Zoning & Subdivision Committee

Thursday, December 13, 2018

Staff Report – Glacier Park Neighborhood Section 11

PRELIMINARY PLAT PLANS FOR JEROME VILLAGE GLACIER PARK NEIGHBORHOOD, SECTION 11

JEROME TOWNSHIP, UNION COUNTY, OHIO
JEROME VILLAGE
GLACIER PARK NEIGHBORHOOD
SECTION 11
COVER SHEET

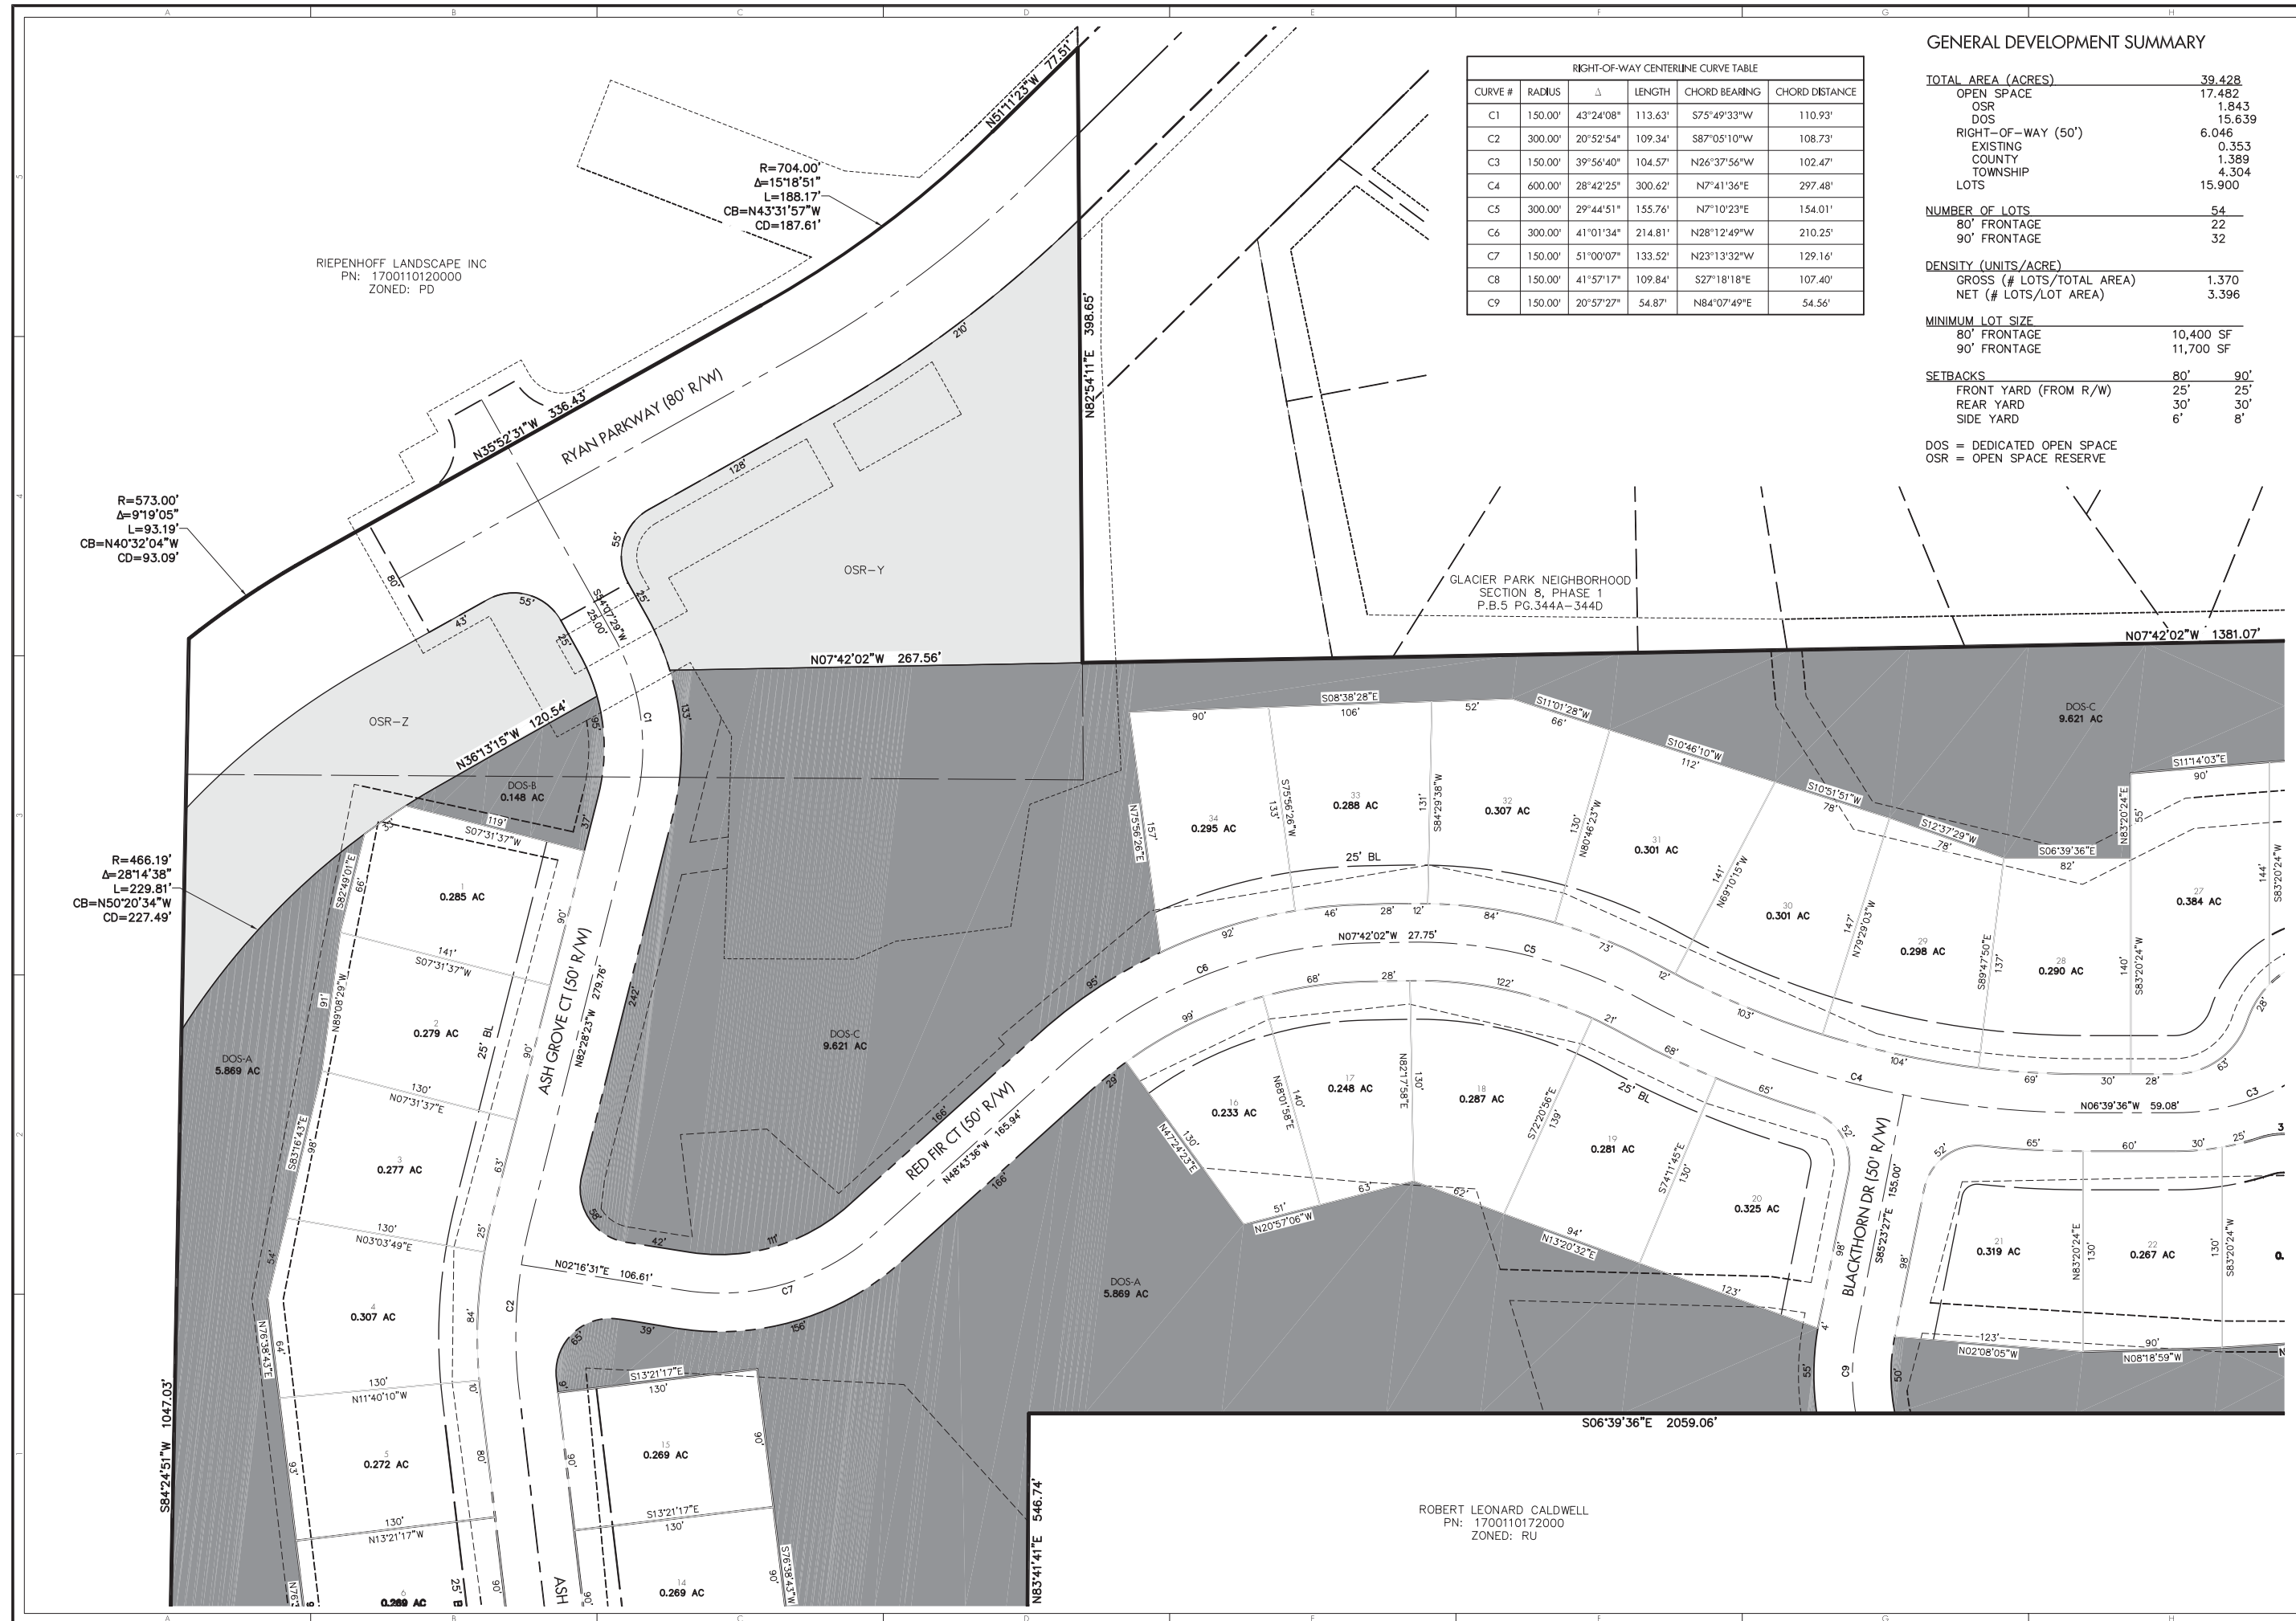
1. Sheet 1 – Added the Development Summary and updated the plan view to include the new stub street.
2. Sheet 5 – Lots 16-36 were redistributed to allow for the stub street. Two of the lots were 90 ft lots are reduced to 85 ft lots.
3. Sheets 6-11 – Incorporated changes to the Utility layout as a result of the lot shift and added stub road.
4. Sheets 13-16 – Adjusted grading illustrated as a result of the Lot line shift.

PRELIMINARY STREET PLAN & PROFILE
 ASH GROVE COURT

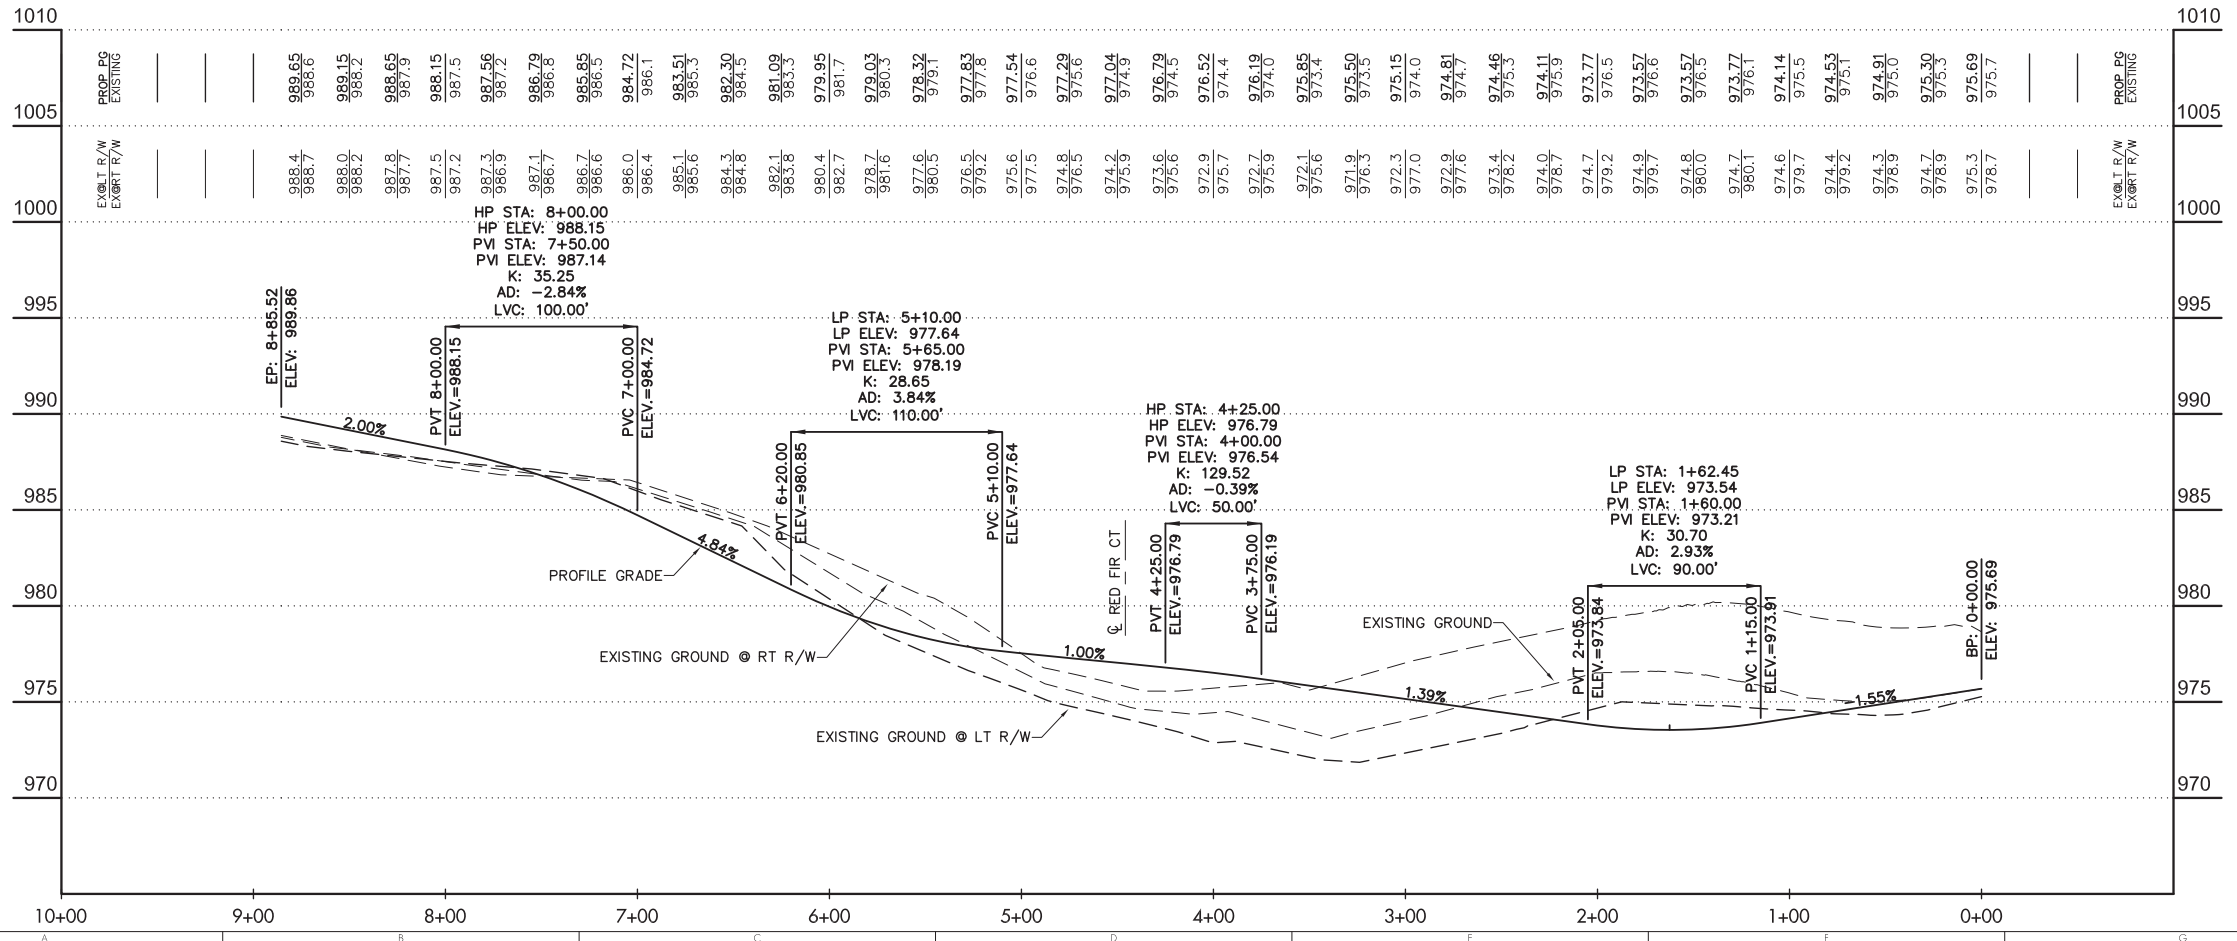
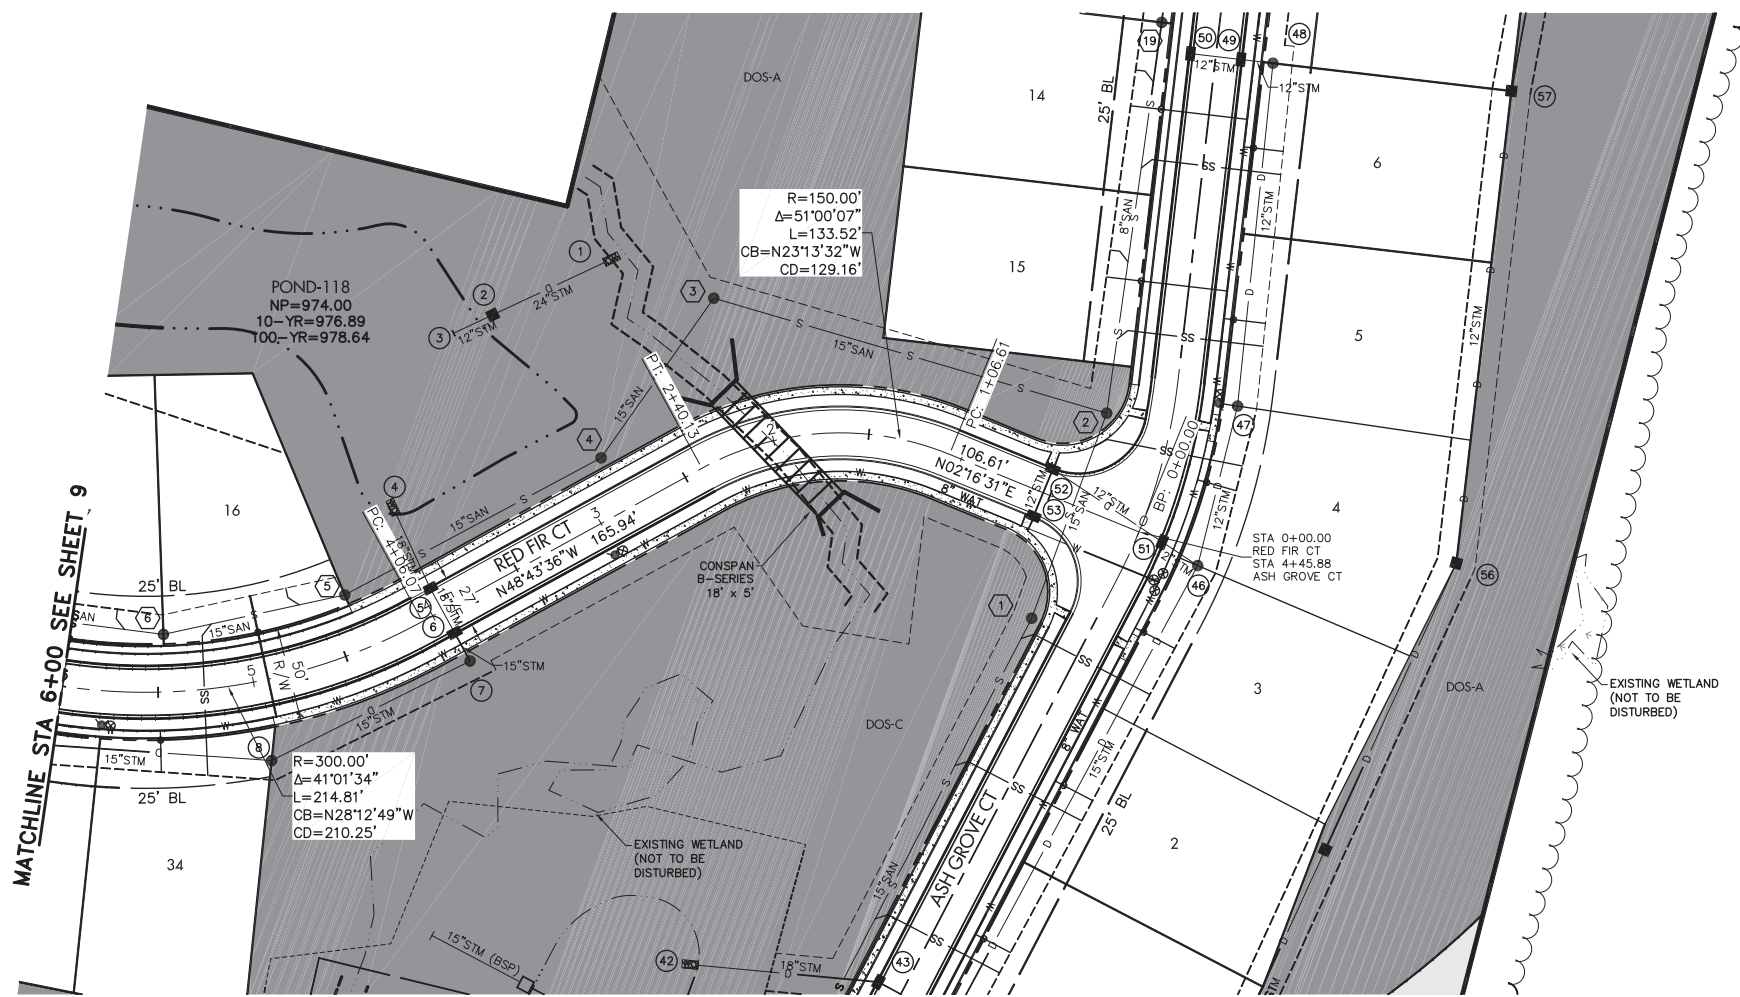
- b) URE will require conduits to be installed under the stream between lots 15 and 16.
 - c) Will need to show electric easements.
- 8) Sheet 8 of 16
- d) Will need to show electric easements.

PRELIMINARY STREET PLAN & PROFILE
RED FIR COURT

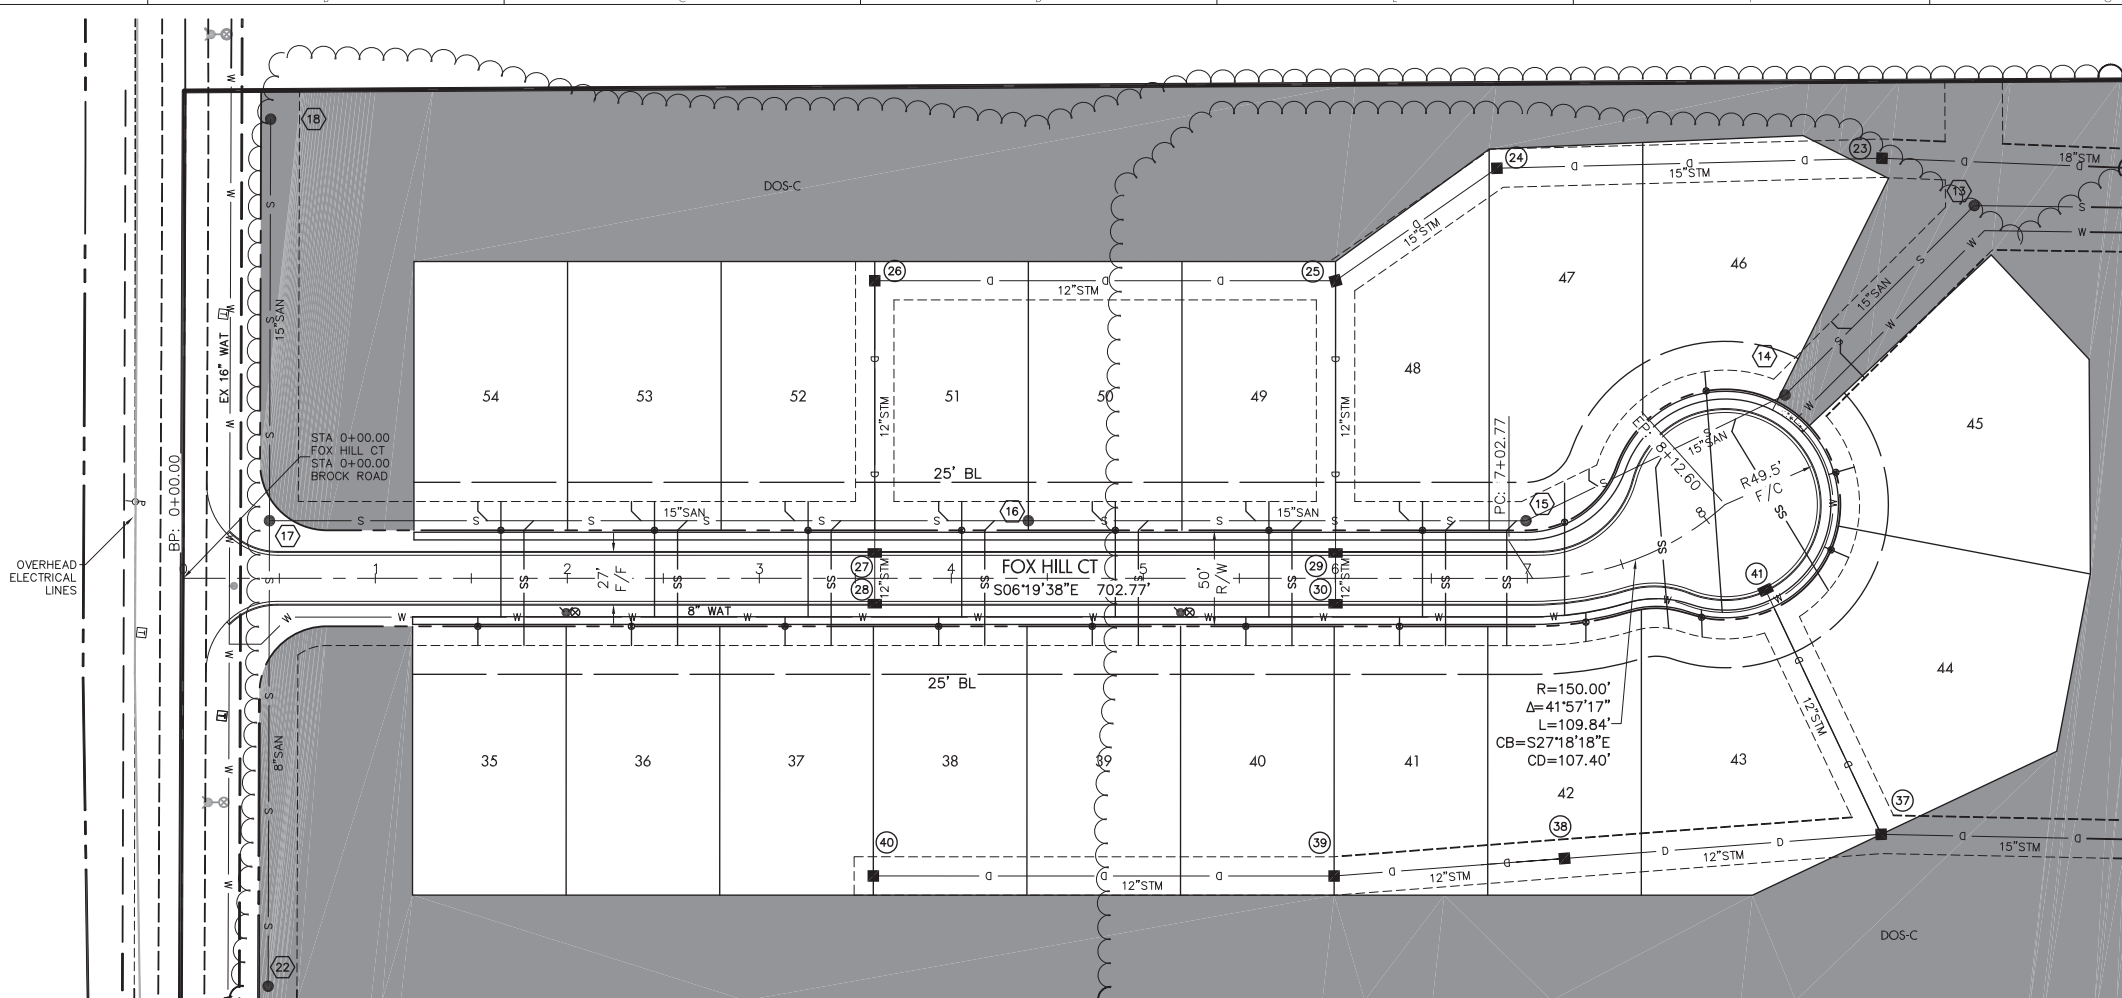
- 9) Sheet 9 of 16
- e) Will need to show electric easements.
- 10) Sheet 10 of 16
- f) Will need to show electric easements.
- 11) Sheet 11 - 16 of 16
- g) No comments

PRELIMINARY STREET PLAN & PROFILE
FOX HILL COURT

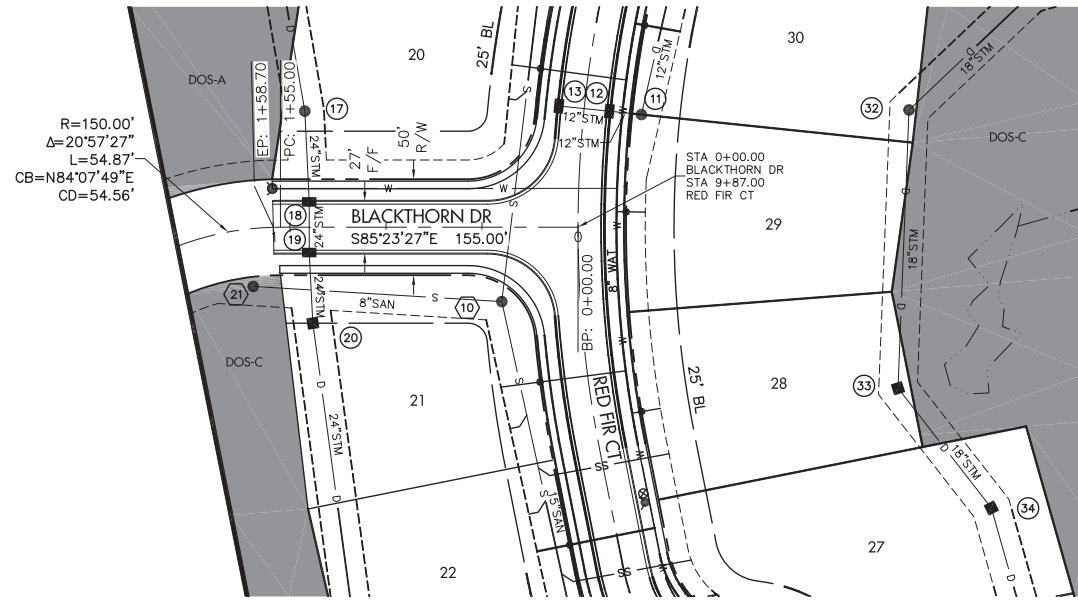
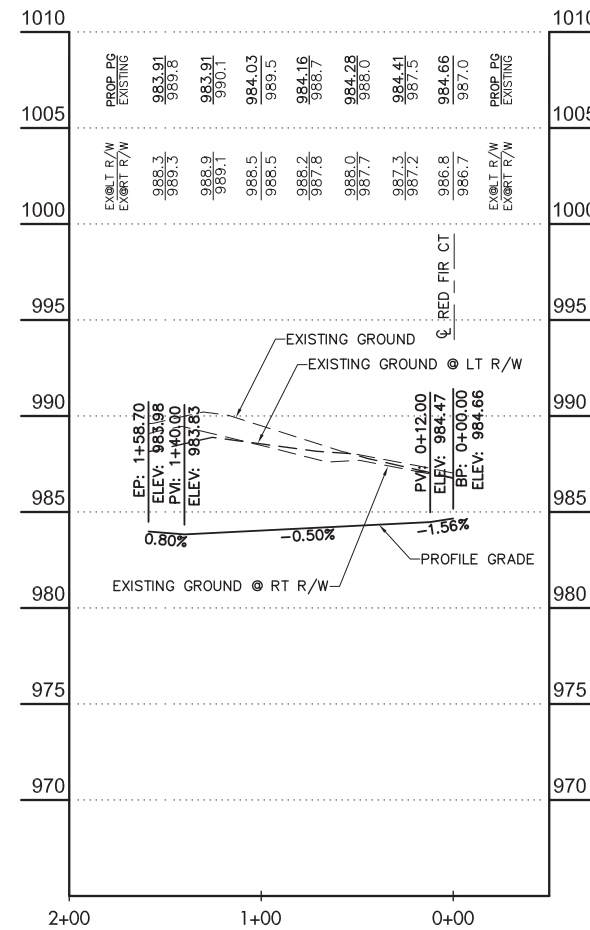
2. The variance request to the Technical Design Standards for maximum cul-de-sac length has been approved by our office for Fox Hill Court.
3. Provide intersection site distance exhibits for access points to Ryan Parkway and Brock Road.
